November 10, 1992

SUBJECT: Calvert Cliffs Nuclear Power Plant  
Unit Nos. 1 & 2; Docket Nos. 50-317 & 50-318  
Response to NRC Request for Additional Information Concerning Relief  
Request from the American Society of Mechanical Engineers (ASME) Code,  
Section III, Article 9, for Calvert Cliffs Nuclear Power Plant, Unit 1  
(TAC No. M83999) and Unit 2 (TAC No. M84000)

OPTION 1 - REMOVE CVC-188

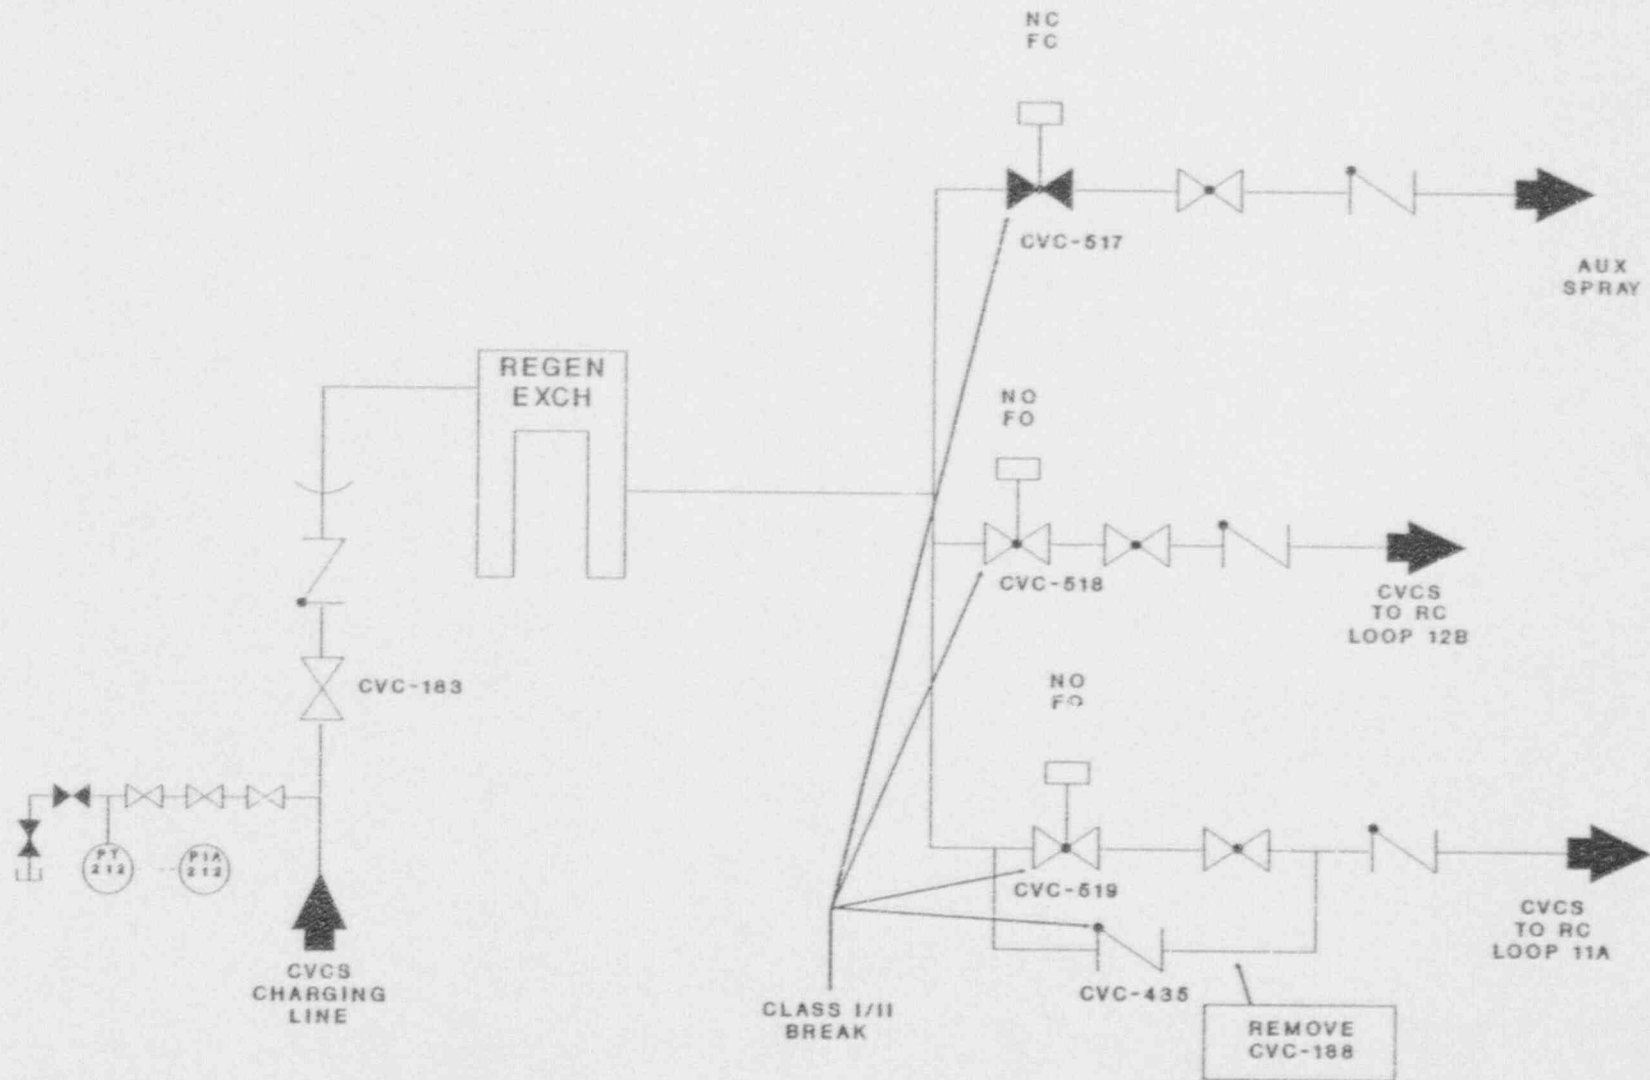
*10 CFR 50.55a provides the staff with two approaches of reviewing and granting relief from ASME Code requirements. 50.55a (a)(3)(i) requires demonstration of an alternative that would provide an acceptable level of quality and safety, and 50.55a(a)(3)(ii) requires demonstration that compliance with Code requirements would result in hardship or unusual difficulties without a compensating increase in the level of quality and safety. BG&E proposes no design changes or system modifications, and has indicated that the cost associated with certain changes or modifications does not offset the minimal increase in safety. Based on 50.55a(a)(3)(ii), provide a cost/benefit analysis to substantiate the sustained hardship or unusual difficulties as a result of complying with the Code requirement.*

##### **Option 1 - Remove CVC-188 (For schematic see Attachment 2.)**

The estimated cost for this modification is \$ 293,000. If this modification were implemented, a freeze seal would have to be performed on the Class 1 section of piping to perform the local leak rate test (LLRT) on CVC-435 and other maintenance activities. The cost of this freeze seal would be about

\$20,000 per Unit, per refueling outage. This modification would present a significant hardship without a compensating increase in the level of quality or safety.
